Re: VCAT Ref: P994/2021
Planning Application Number: P/2020/6237
2-8 ST ELMO AVENUE, Ferntree Gully

Amended Plans to VCAT Review

Statement of Changes to Plans

Drawing Title		NORTH AND EAST ELEVATIONS	
Drawn	Scale 1:100 @ A1	dwg no.	TP07
Leader	Date 21/02/22	rev.	5

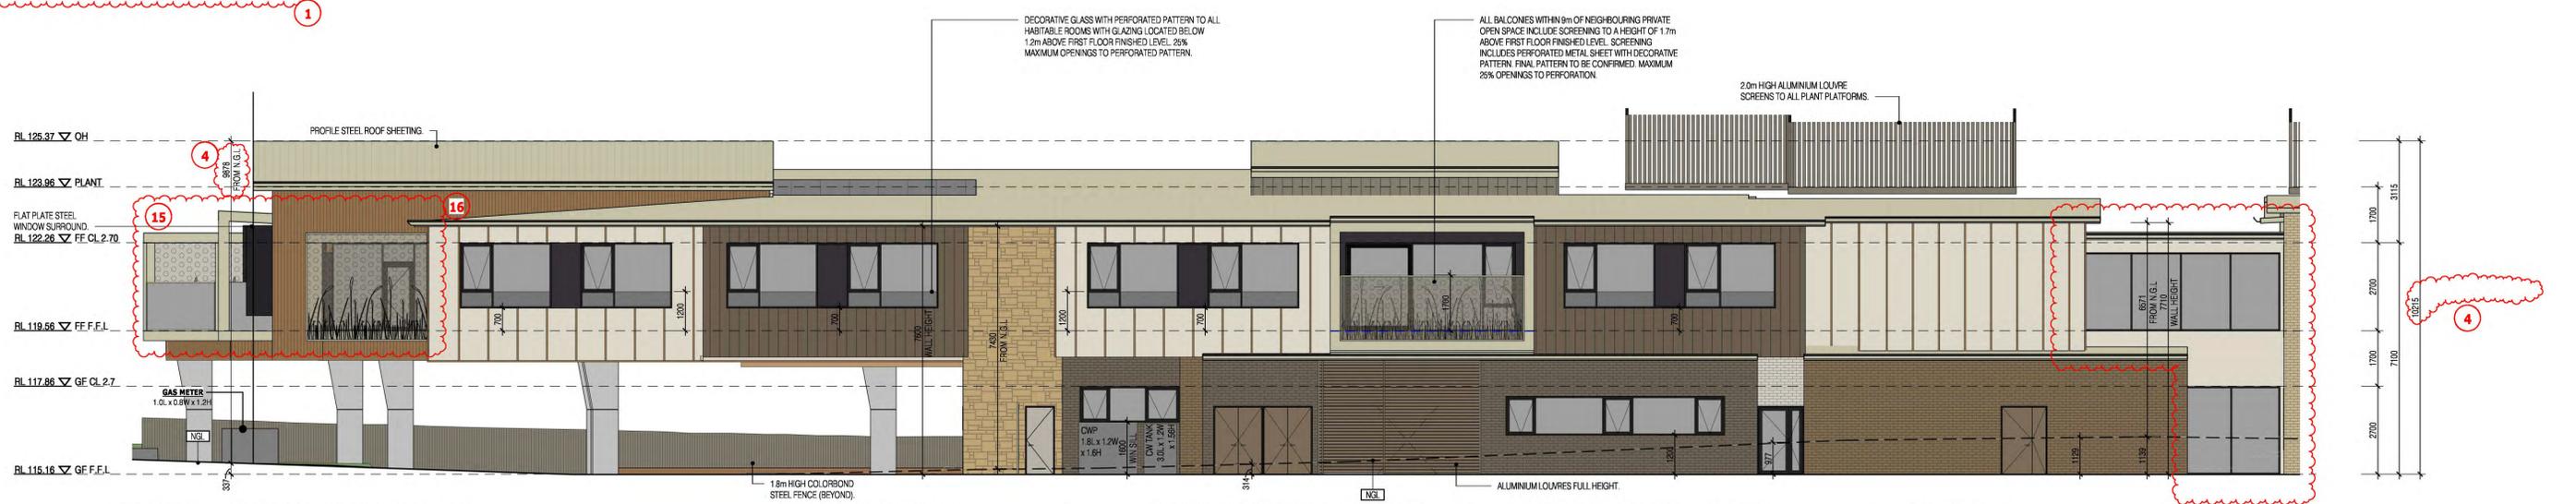
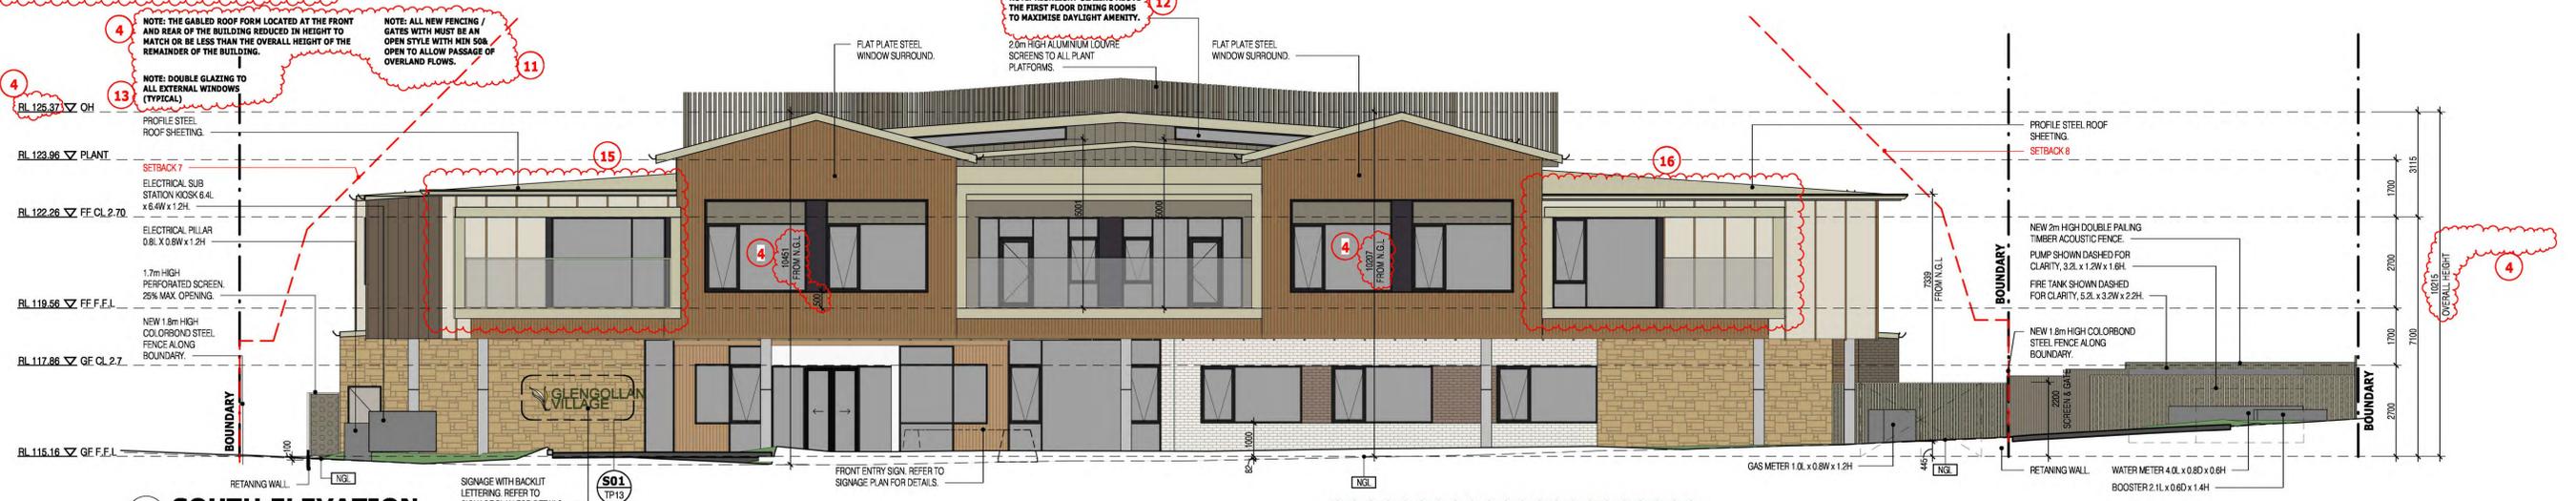
4	Gable roof heights reduced to match overall height of remainder of building.	TP07, TP08, TP09, TP11, TP12, TP13, TP14
5	Note added: 'The recently installed NBN double pit located in the nature strip must not be impacted by the new crossover.'	TP03, TP04
6	Note added: 'Carefully remove & relocate tree no. 13 to the rear of the site.'	TP02, TP03
7	Note added: 'The Redundant crossovers must be removed and the kerb and channel and nature strip reinstated to Council standards.'	TP03, TP04
8	Southern crossover modified to be at a right angle to St Elmo Ave.	TP03, TP04, TP05
9	Note added: 'Only vehicles with a maximum length of 7.2 metres or less are permitted to access the site.'	T003, TP04
10	Deletion of proposed footpath on nature strip & connections to nearest existing footpaths.	T003, TP04
11	Note added: 'Any new fencing/gates must be of an open style of construction (minimum 50% open) to allow for the passage of overland flows.'	TP03, TP04, TP07, TP08, TP09

12	Note added: 'Highlight glazing above the First Floor dining rooms to maximise daylight amenity.'	TP07, TP08
13	Note added: 'Double glazing for all external windows.'	TP03, TP04, TP05, TP07, TP08, TP09
14	Note added: '3x bike racks (min).'	TP03, TP04

15	New trees with larger canopies added to western boundary for screening purposes. Trees are located adjacent to the private open spaces of neighbouring dwellings. The ground floor, first floor & elevations have been modified to accommodate the new tree canopies. The first floor balcony facing the neighbouring dwelling has been deleted. Building set back dimensions & shadow diagrams have been updated. Refer landscape plans for tree details.	TP03, TP04, TP05, TP06, TP08, TP09, TP11, TP12, TP14
16	Structural columns added on the first floor to support balcony roofs located at external corners of the building.	TP05, TP07, TP08, TP09

3D PERSPECTIVE 01

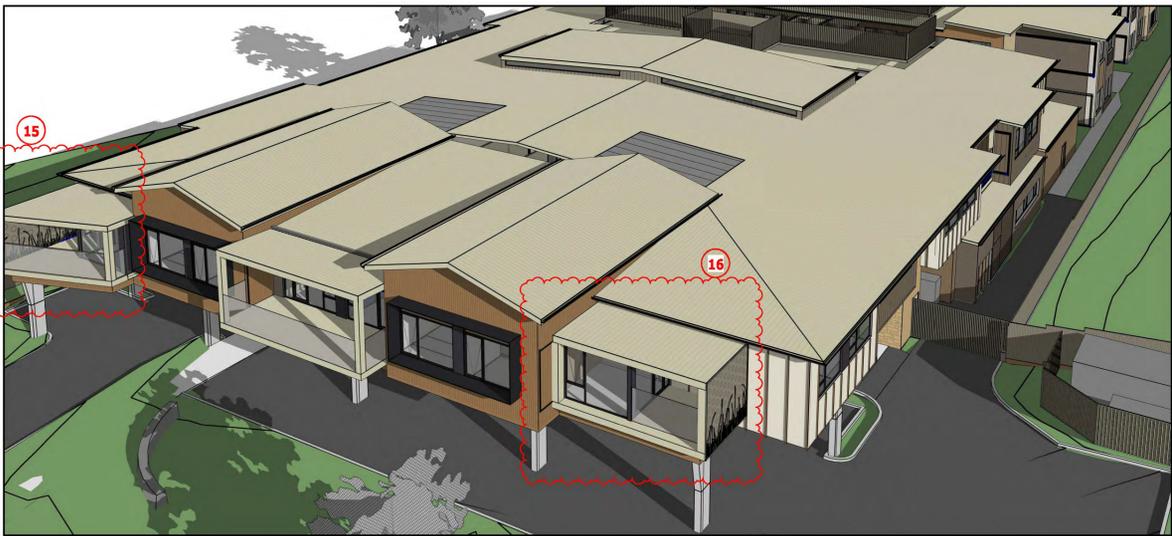
4 NOTE: THE GABLED ROOF FORM LOCATED AT THE FRONT AND REAR OF THE BUILDING REDUCED IN HEIGHT TO MATCH OR BE LESS THAN THE OVERALL HEIGHT OF THE REMAINDER OF THE BUILDING.

11 NOTE: ALL NEW FENCING / GATES WITH MUST BE AN OPEN STYLE WITH MIN 500 OPEN TO ALLOW PASSAGE OF OVERLAND FLOWS.

13 NOTE: DOUBLE GLAZING TO ALL EXTERIOR WINDOWS (TYPICAL)

Drawing Title SECTIONS	Scale As indicated @ A1	dwg no. TP13	rev. 4
Drawn	Date 21/02/22	Leader	PRINT STAMP: 1/02/2022 12:27:36 PM Z:\BHA TEMP\Glengollan Village (19011)\REVIT\19011_GV_TP_RVT20_REV04.rvt

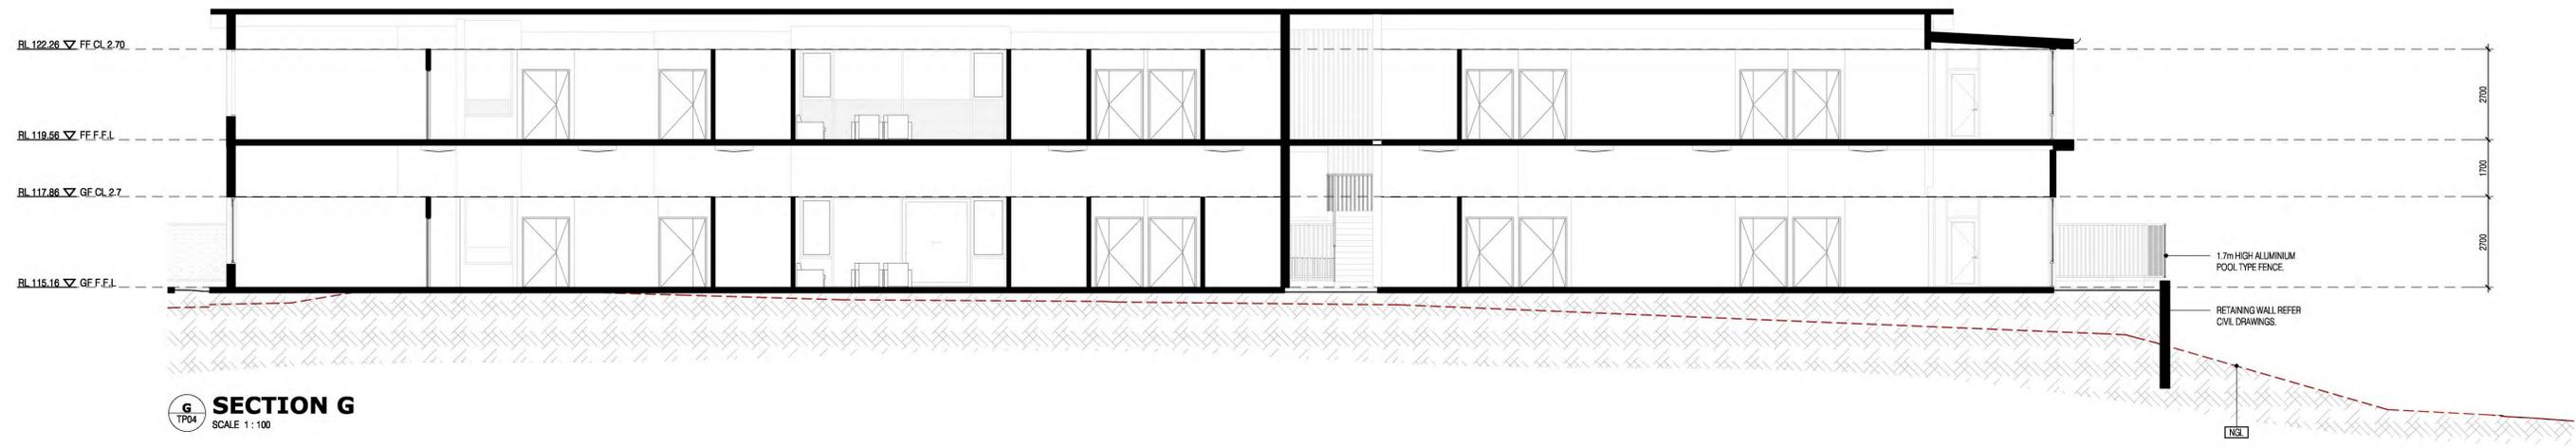
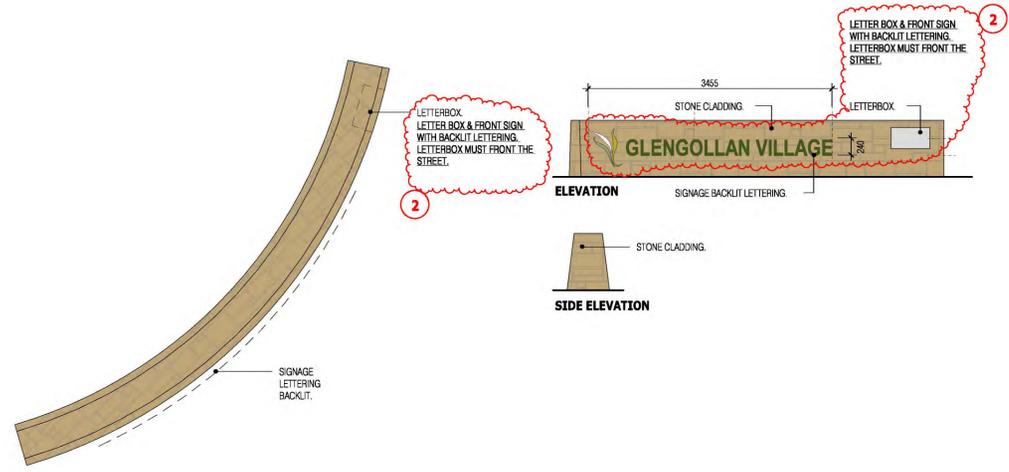
CHANGE No.	DESCRIPTION	DRAWING No.
1	Note added: 'VCAT amending plans.'	All sheets
2	Note added: 'All structures (including fences, letterboxes, landscaping and meter boxes) must be constructed to a maximum height of 900mm or relocated clear of a splayed area near the access way to ensure safe sight distances.' Letterboxes must front the street.'	TP03, TP04, TP13
3	Notes referencing water tanks deleted.	TP03, TP04
